IEEE P802.11
Wireless Access Method and Physical Layer Specifications

Title: Proposed Revisions to the MAC Frame Formats.

This submission contains the proposed changes for section 4.1 of the draft standard. It is to replace the current section 4.1 in the B3 draft. The paper is a copy of the B3 draft with the necessary changes included.

Figure 4-3: MID Field

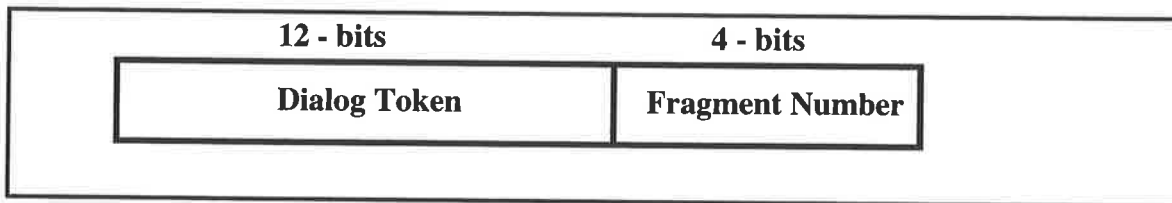
In addition it includes a change in the FC field to implement the "Final" bit indicating a Final Fragment.

The F bit will indicate that this MPDU is the "Final or only" fragment of the MSDU.

The MID field consist of two subfields as indicated by figure 4.3. It consist of a 12 bit Dialog Token (DT) field, and a 4 bit Fragment Number field.
